Agenda
Village of Arlington Heights
Design Commission
Community Room, 3rd Floor

Arlington Heights Village Hall
33 S. Arlington Heights Road
Arlington Heights, IL 60005
August 11, 2015
6:30 PM

STAFF DESIGN COMMISSION REPORT

Project Name: 131 S. Fernandez Ave.
Project Address: 131 S. Fernandez Ave.
Prepared By: Steve Hautzinger

PROPOSED CONTEXT ELEVATION

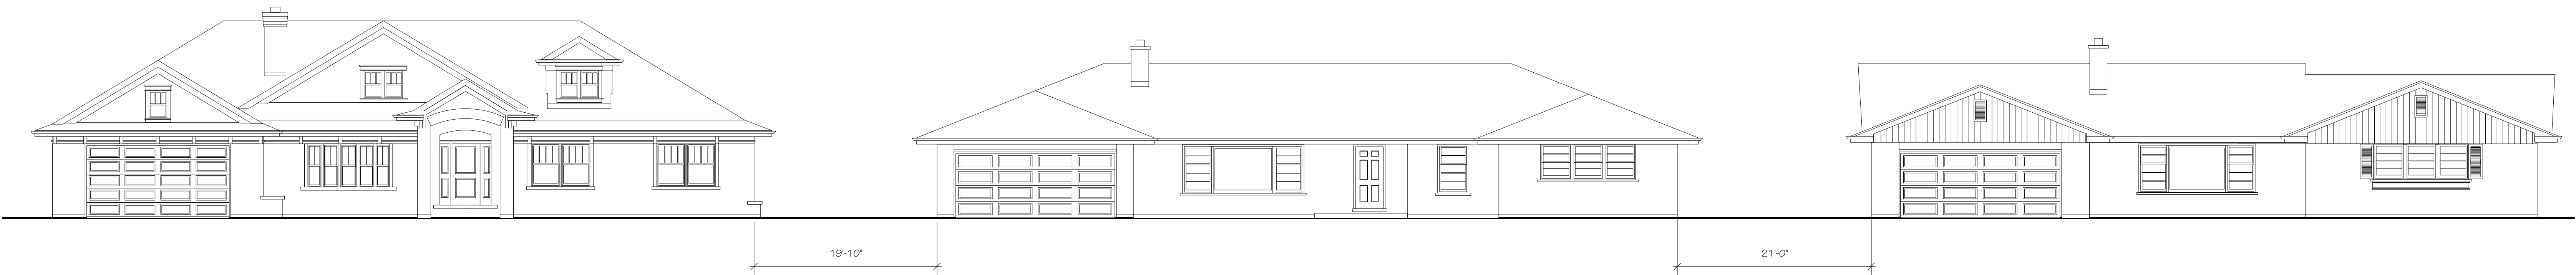
1. A recommendation to eliminate the two story wall on the south elevation.
2. This review deals with architectural design only and should not be construed to be an approval of, or to have any other impact on, any other zoning and/or land use issues or decisions that stem from zoning, building, signage or any other reviews. In addition to the normal technical review, permit drawings will be reviewed for consistency with the Design Commission and any other Commission or Board approval conditions. It is the architect/homeowner/builder's responsibility to comply with the Design Commission approval and ensure that building permit plans comply with all zoning code, building permit and signage requirements.
3. Compliance with all applicable Federal, State, and Village codes, regulations and policies.

The existing neighborhood consists of a mix of single story and two story homes with attached, front loading garages. However, this block is all single family homes with the exception of one low-profile one and a half story home on the lot directly to the north, and the proposed house will be the first full two story house on the block. The proposed house is large, but it does fit comfortably on the large lot. Overall, the house is nicely designed with a variety of materials and nice details. The single story front porch helps the design of the house to relate to the single story neighborhood, but it is recommended that the layout of the second floor be adjusted to eliminate the two story wall on the south elevation. The single story roof on the north elevation works very well to ease the transition up to the second floor. Ideally, the south elevation would be revised to be similar to the north elevation.

FRONT ELEVATION - PROPOSED

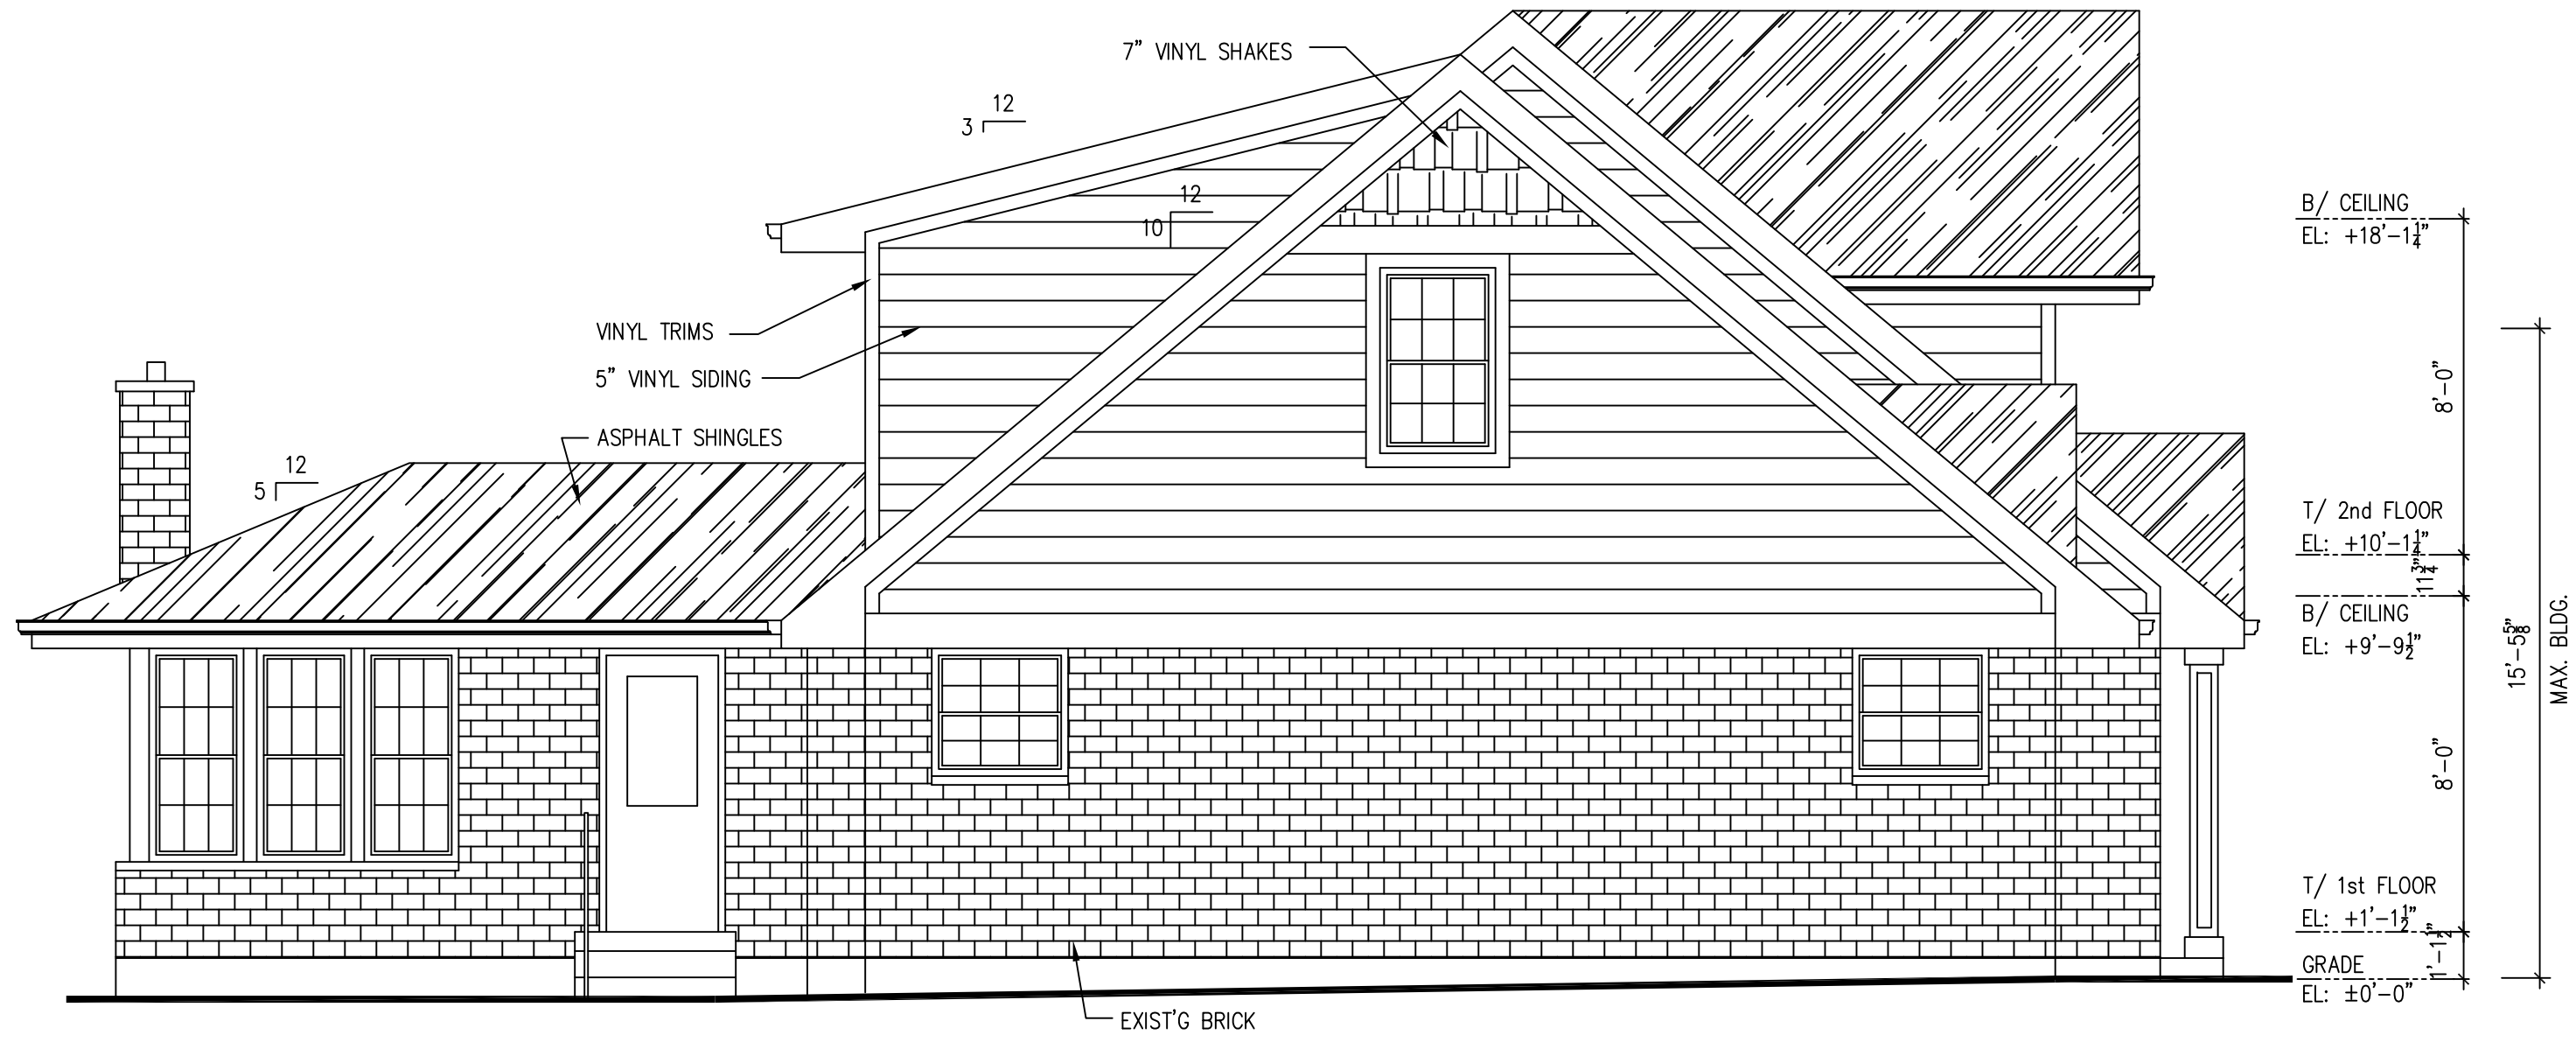
1. Adjust the first floor master bedroom windows on the left side of the front elevation to be centered on the wall.
2. Replace the small gable vent dormer detail with a single window dormer with detailing to match the main double window dormer on the front elevation.

To enhance the design, it is recommended that the new master bedroom windows on the left side of the first floor front wall be centered on the wall, and that the small gable vent dormer detail on the roof above be replaced with a single window dormer with detailing to match the main double window dormer on the front elevation.

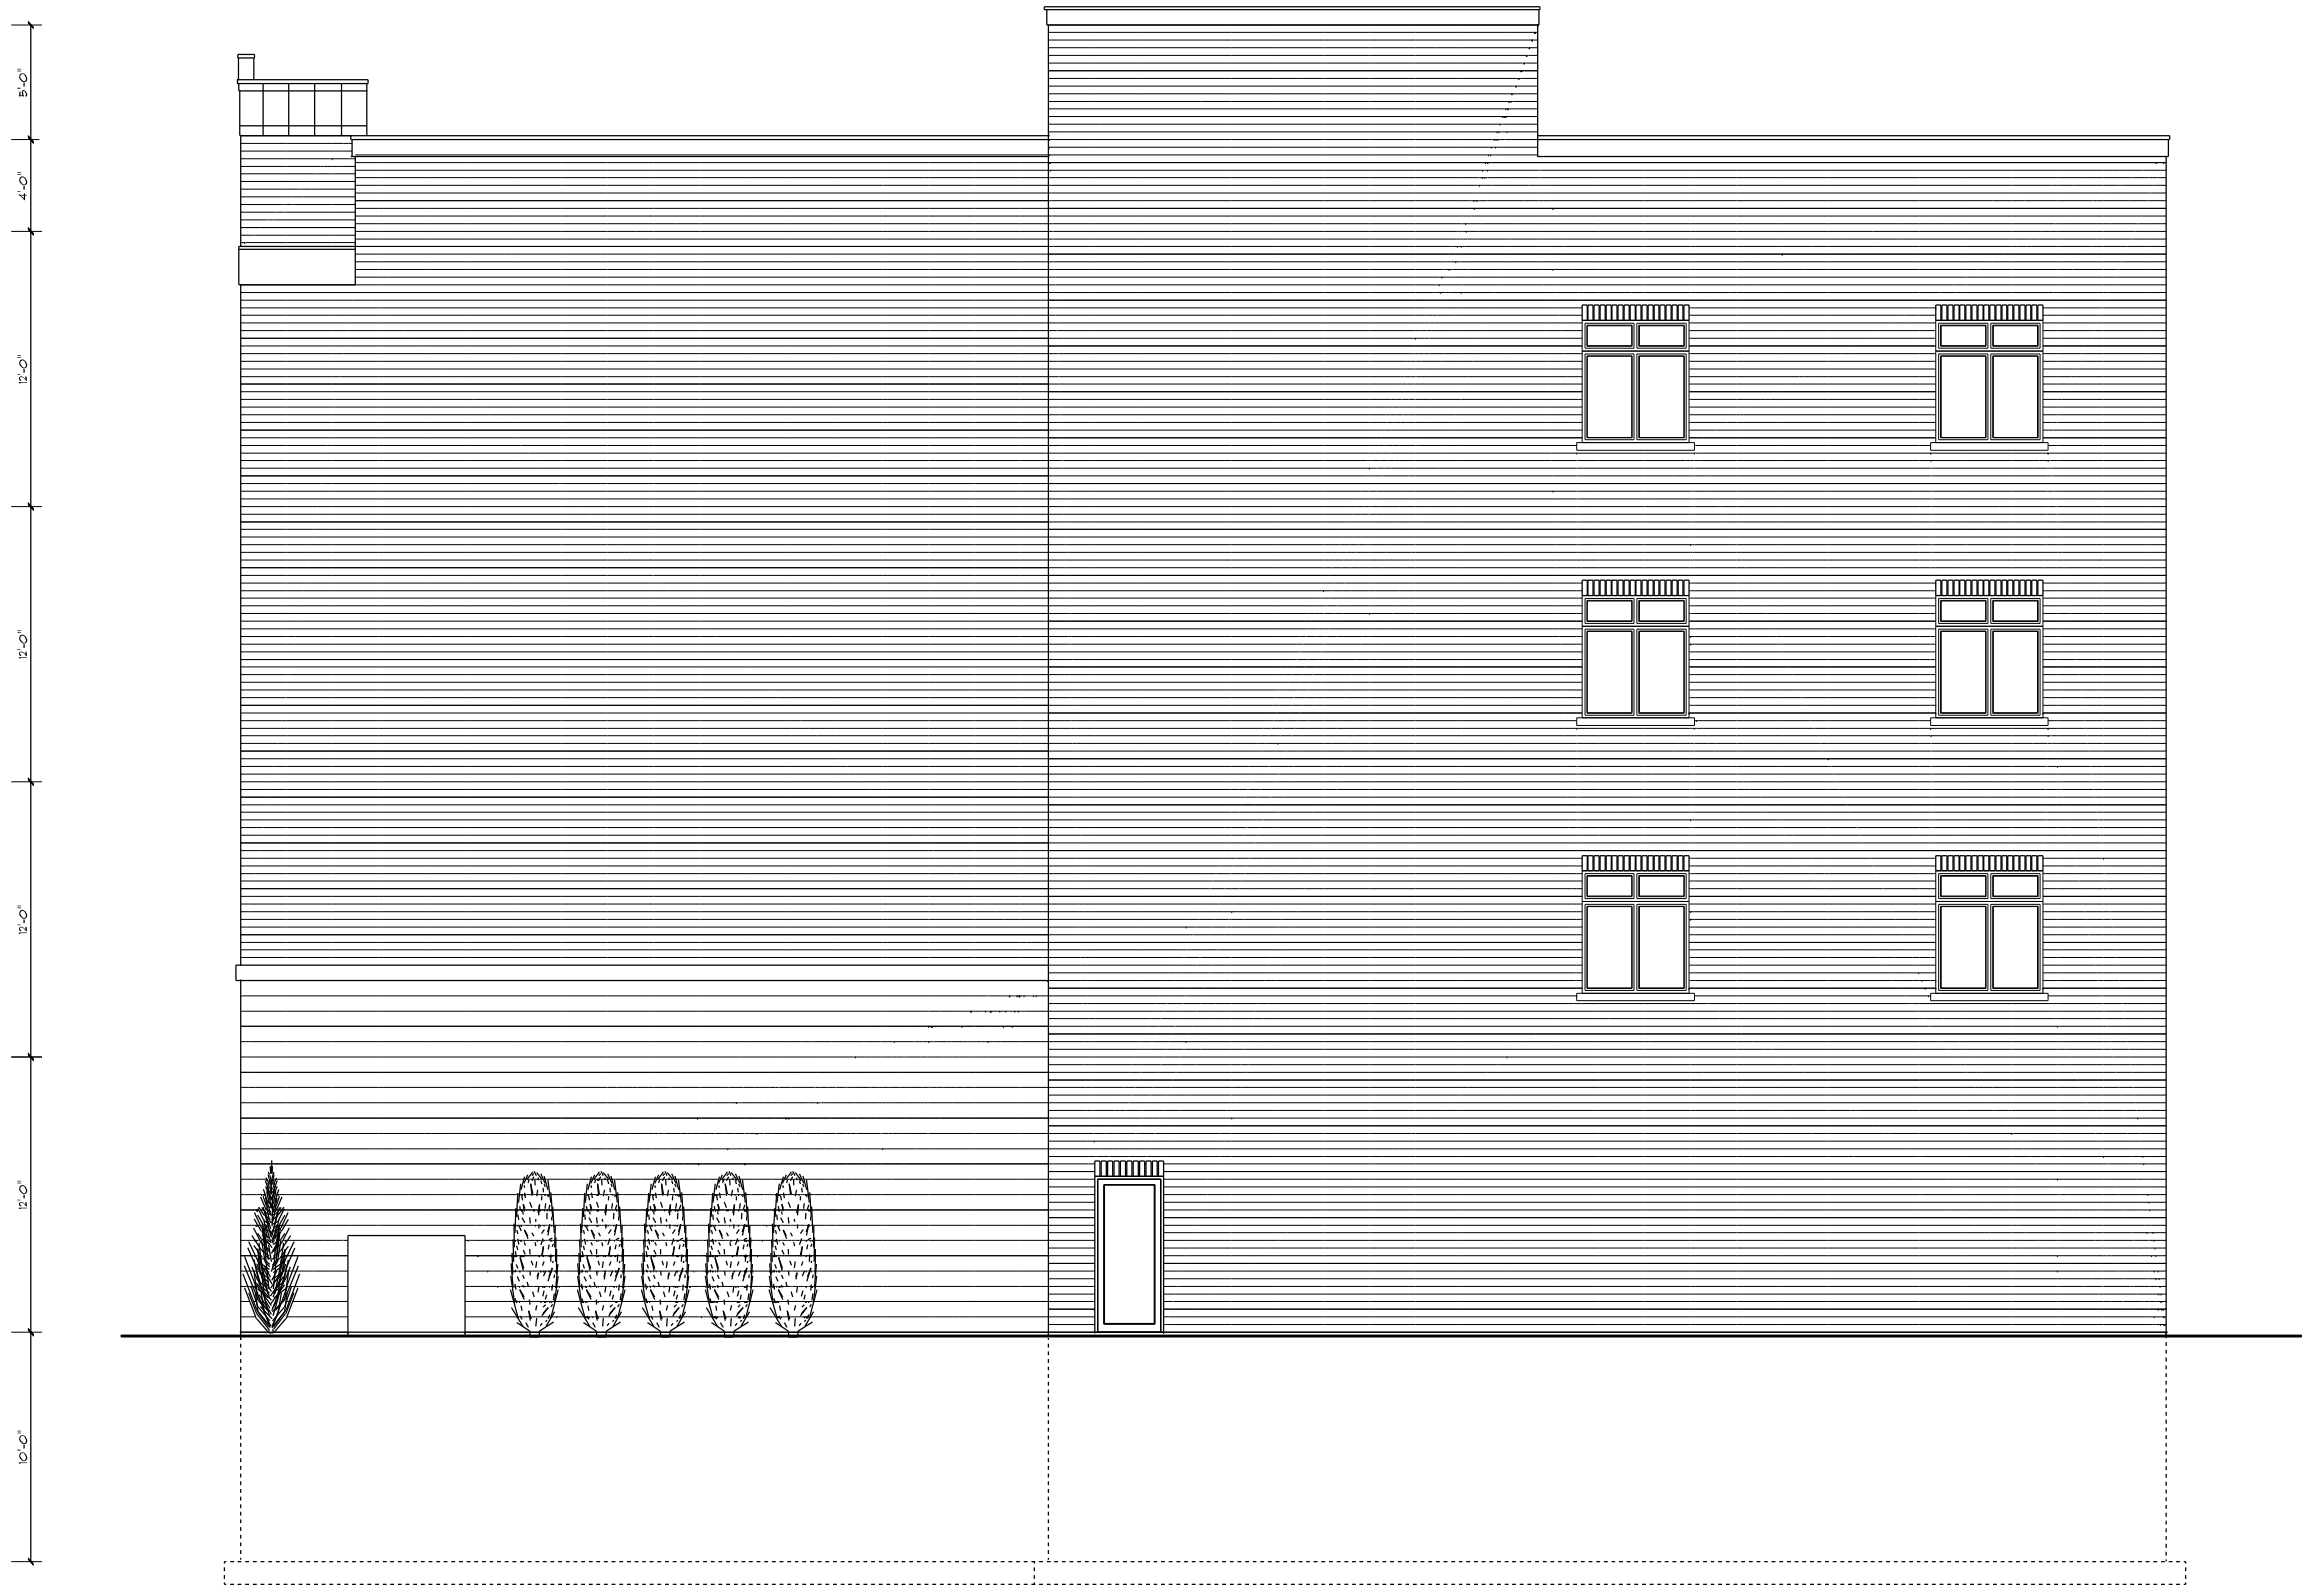
4. Retail storefronts should be added on the first floor to add visual interest at the sidewalk level, and to enliven this area of the Downtown.
5. The small arches and keystones above the windows and balcony doors are weak. Consider a straight, stone lintel detail with a heavier appearance in lieu of the arch detail.

6. The brick wall area above the top floor windows is blank and void of detail. Consider adding more details in this area such as decorative brick and stone detailing.

7. The arched cornice at the top of the building and arched lintel above the first floor garage door are awkward. Consider omitting the arch, and providing a built-up linear stone detail instead.

8. The proposed railing detail at the roof deck level is a nice detail, but it is proposed to be set back from the front wall. Consider moving this detail forward to be in line with the front wall so that it is more visible and aligns with the balcony railings below.
